# JOINT REGIONAL PLANNING PANEL (SYDNEY EAST)

## Assessment Report and Recommendation Cover Sheet

JRPP No	<b>2015SYE115</b>
DA Number	<b>2015/100</b>
Local Government Area	<b>Strathfield</b>
Proposed Development	Demolition of the existing clubhouse and structures, tree removal and Staged construction of (23) x two (2) 2 storey townhouses, (27) x three (3) storey townhouses and two (2) 2 x nine (9) 9 storey apartment buildings (178 dwellings) over two (2) levels of basement car parking for (321) cars
Street Address	<b>84 Centenary Drive, Strathfield</b>
Applicant/Owner	Alceon Group Pty Ltd – C/- Metro Property Group
Number of Submissions	<b>Six (6)</b>
Regional Development Criteria (Schedule 4A of the Act)	<b>CIV &gt; \$20m</b> \$81,203,834
List of All Relevant s79C(1)(a) Matters	<ul style="list-style-type: none"> <li>• <b>List all of the relevant environmental planning instruments: s79C(1)(a)(i)</b> <ul style="list-style-type: none"> <li>• SEPP 55 – Remediation of Land</li> <li>• SEPP 65 – Design Quality of Residential Flat Buildings</li> <li>• SEPP (Infrastructure) 2007</li> <li>• SEPP (Building Sustainability Index: BASIX) 2004</li> <li>• Strathfield Local Environmental Plan 20

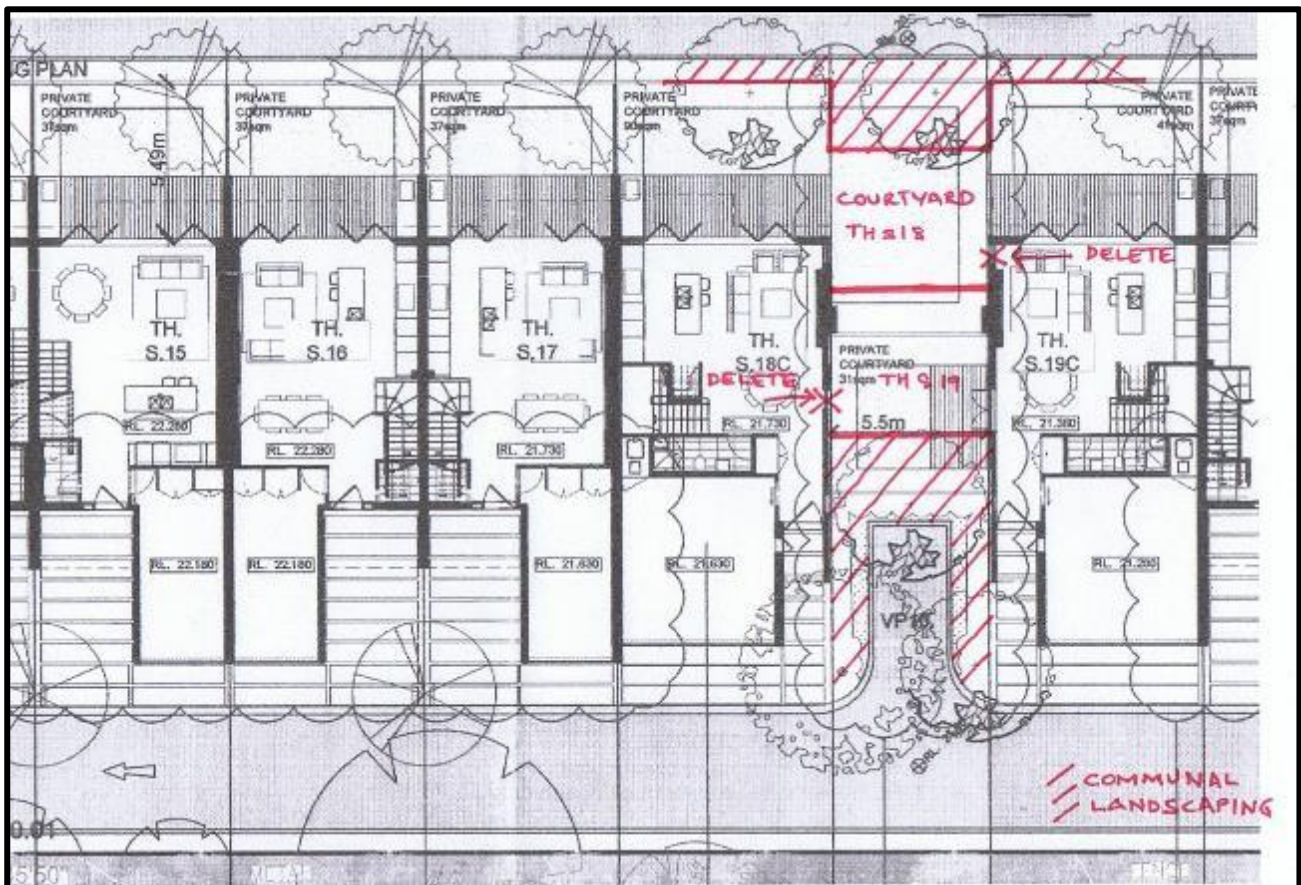
The plans have been amended to remove the north/south link roads and courtyard spaces have been provided in this space, along with one (1) visitor parking space. The separation between the townhouses was not reduced and remains at 5.5m. Whilst the amended plans are generally acceptable in this regard, the amended design raises some concerns which are addressed as follows.

The intention of the removal of the north/south link roads was to provide for increased deep soil plantings and to provide a substantial improvement to the landscape setting of the development. The amendments incorporate the vast majority of this space into the private courtyards of the two (2) adjoining townhouses, which as a result has very limited visible improvement to the landscape setting of the townhouses.

Whilst the use of part of this space for private courtyards is reasonable, the size of this area should be reduced to improve the landscape setting of the development. An improvement in the landscape setting of the development could be achieved by providing a 3m deep common landscape area to either side of the private courtyards (i.e. adjoining the northern loop road and to the rear of the visitor parking space off the southern loop road), with 5m wide courtyards between.

These amendments will require changes to the architectural and landscape plans and it is important for Council to ensure the desired landscape setting is achieved. It is therefore recommended that the amended plans be required by way of a deferred commencement condition. The amended landscape plan should incorporate a canopy tree to reach a height of 15m in the 3m landscaped area to either side of the private courtyards. **Condition D2** incorporates these requirements. The following sketch identifies the amendments that are sought by this condition.

In terms of increasing the landscape setting of the northern townhouses, the amended landscape plans show little change. Accordingly, it is recommended that a condition of consent include a requirement to amend the landscape plan to provide for a small tree (5-6m at maturity – can be deciduous) in the courtyard of each northern townhouse. In order to increase the landscaped setting of the area surrounding the single storey components and to allow the bulk to be broken in these locations, the tree to be planted in the courtyards of Townhouses N4, 5, 9, 10, 14, 15, 19 and 20 are to achieve a minimum maturity height of 10m. This requirement is addressed by **Condition D2**.

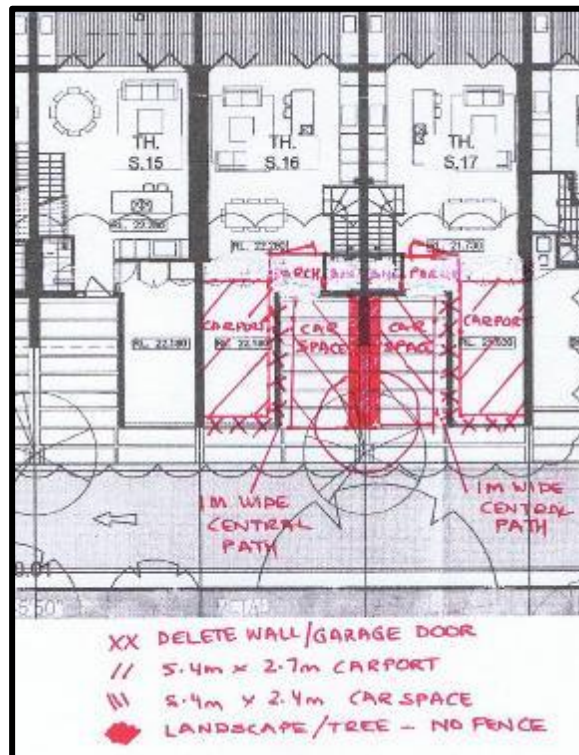
Amended plans have been provided which have increased the width of the open single parking space and increased the depth of that space and the garage to provide for improved manoeuvrability into the spaces along with allowing an access path to the front door clear of the parking space.

The amended plans do not provide sufficient space for appropriate manoeuvring into the space together with suitable access into the dwelling. Further, the modifications made to the plans are at the expense of the landscaped setting at the front of the townhouses. Whilst a tree has been retained forward of the parking spaces, its location inhibits manoeuvrability into the spaces and the spaces are only accessible by way of a three point turn.

The combination of poor accessibility, the proximity that the car would need to be parked to the front door and the loss of landscape setting demonstrate that at 6.8m wide, the townhouses are of insufficient width to provide an appropriate entrance pathway, single garage and open car space.

Accordingly, it is recommended that the plans (both architectural and landscape) be amended to achieve a better outcome for parking, access and the landscaped setting. The following amendments demonstrate an example of one way which this could be achieved:

It is acknowledged that this will reduce the size of the living spaces to these townhouses. Should the above solution not result in an acceptable level of amenity, an alternative would be to delete one (1) townhouse and increase the width of the remaining southern townhouses, although this would have to be achieved within the permitted FSR for the site.

**Condition D2** addresses these modifications.
